Design Review Committee Meeting

4.I. Miller Lowry Developments Village Walk Hapeville - New Multi-Use Development

4.II. Daniel Love 417 Walnut Street - New SF Dwelling
Background:

RE: Design Review – Village Walk at Hapeville Revised October 2020

HOUSE LOCATION PLAN FOR:
417 WALNUT STREET

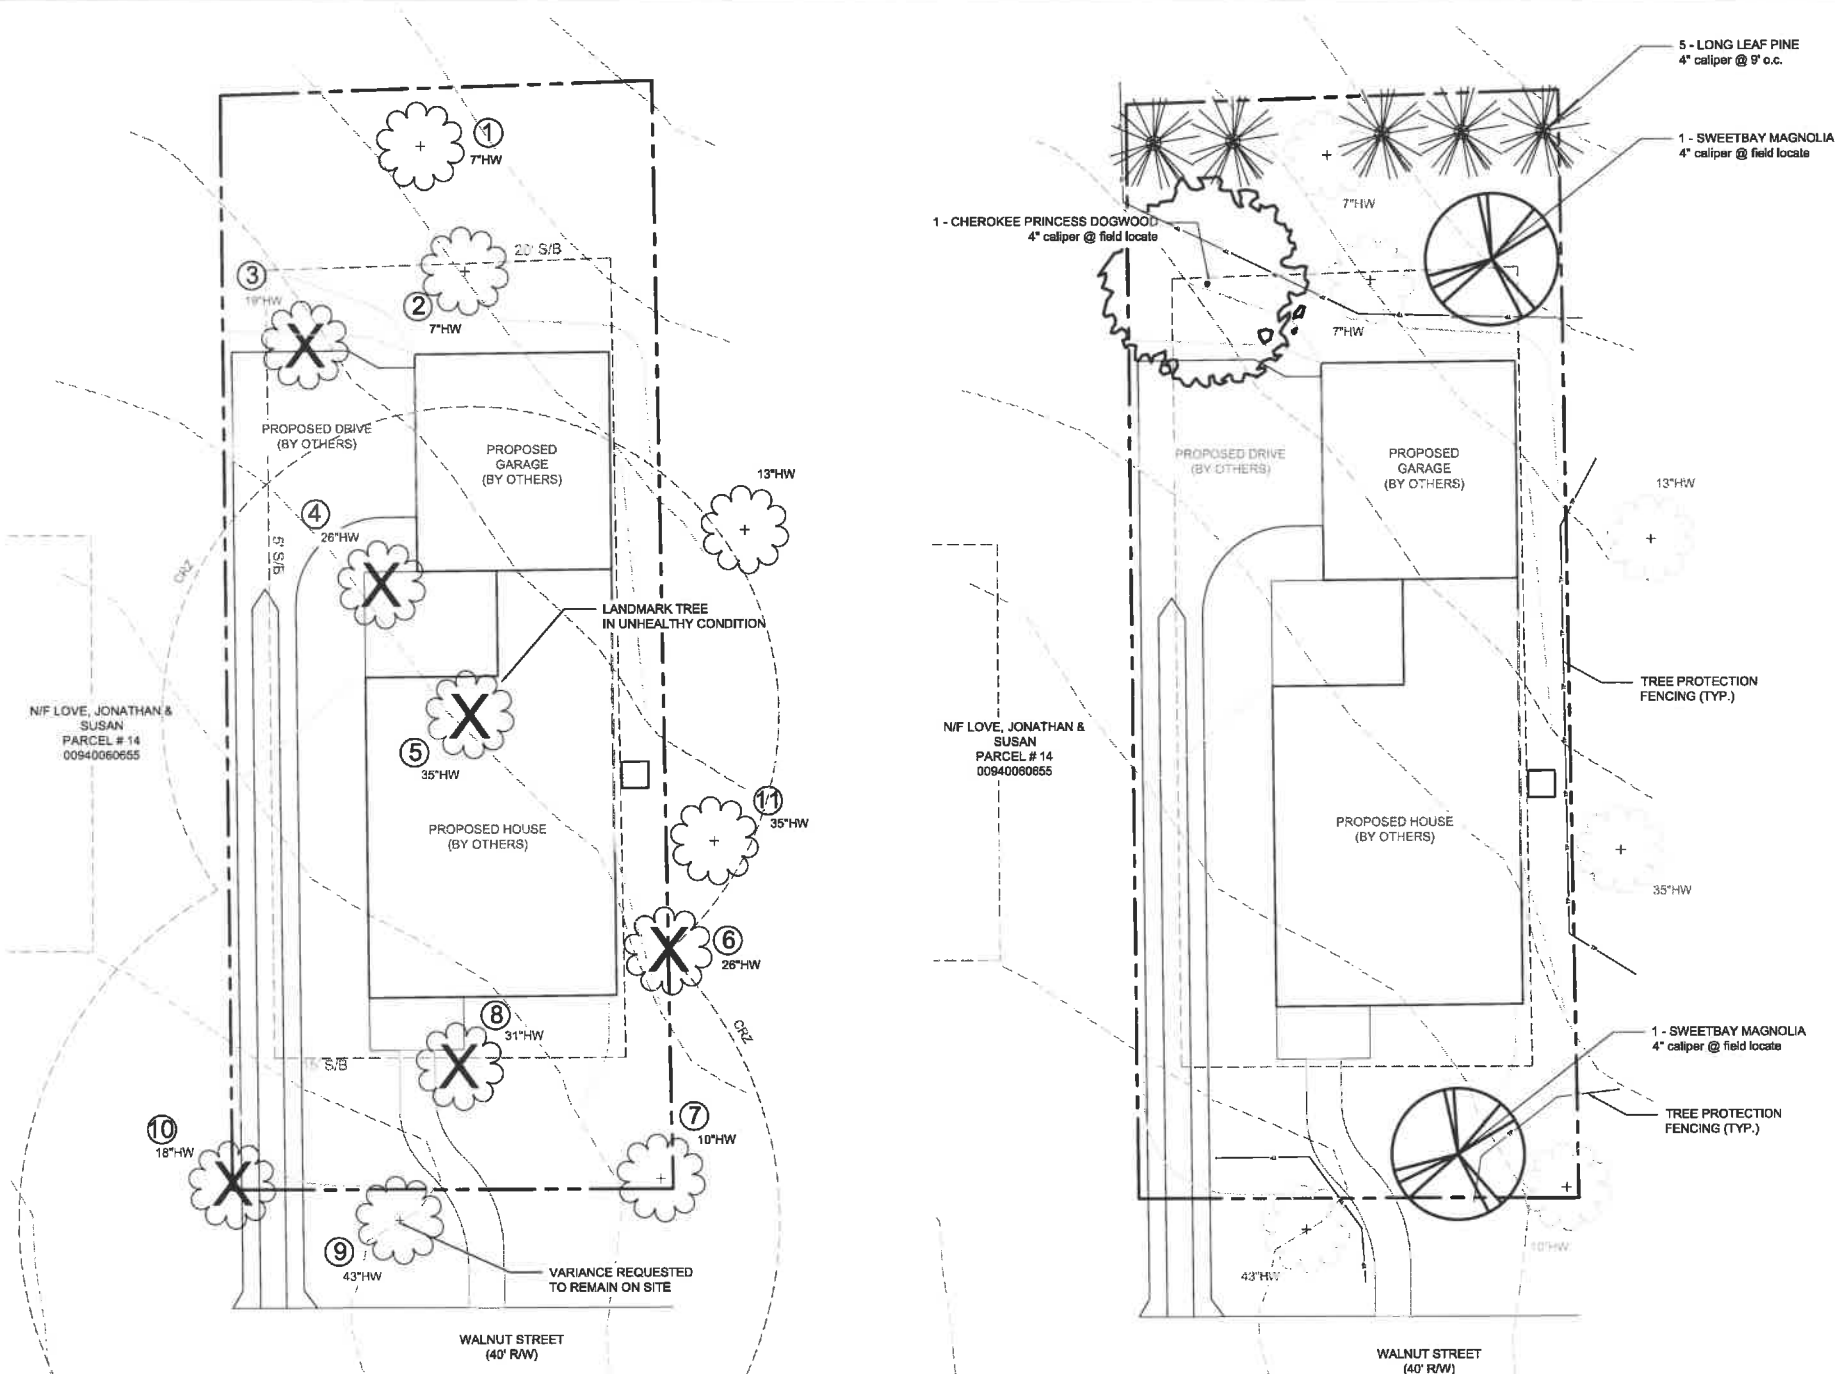
STAFF COMMENT: **The plans do not show a sidewalk – presumptively to save the 43” Oak. A design exception is requested.**

STAFF COMMENT: **No sidewalk is shown but plantings are present at the back of curb.**

STAFF COMMENT: Driveway width is 7' – a design exception is requested.

A.1

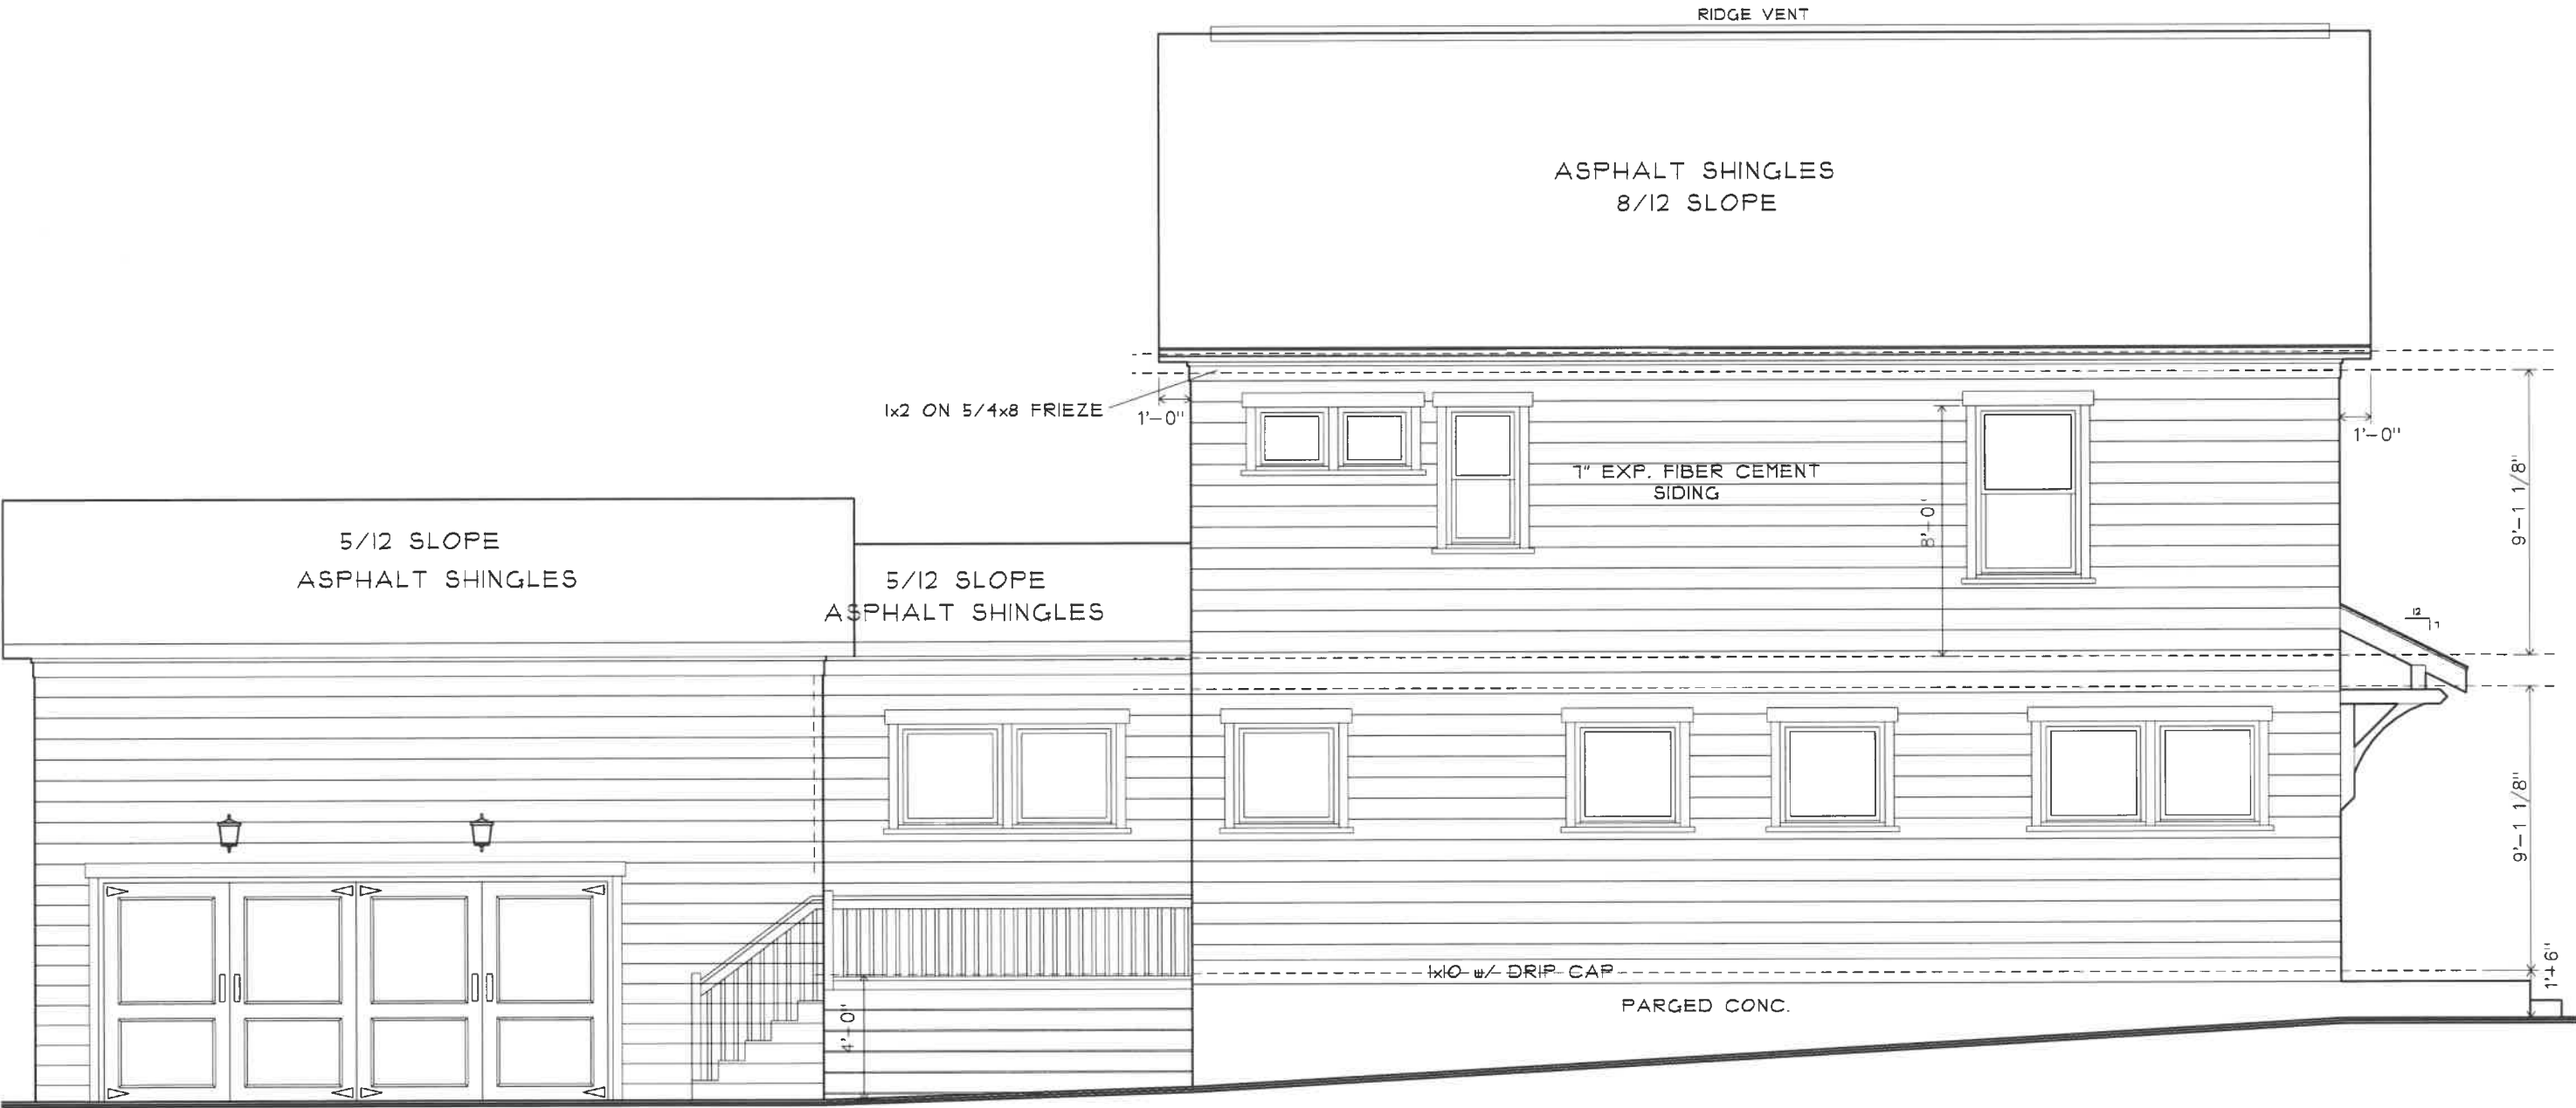
STAFF COMMENT: **Dimensions for mullions not indicated on side grouped windows.**
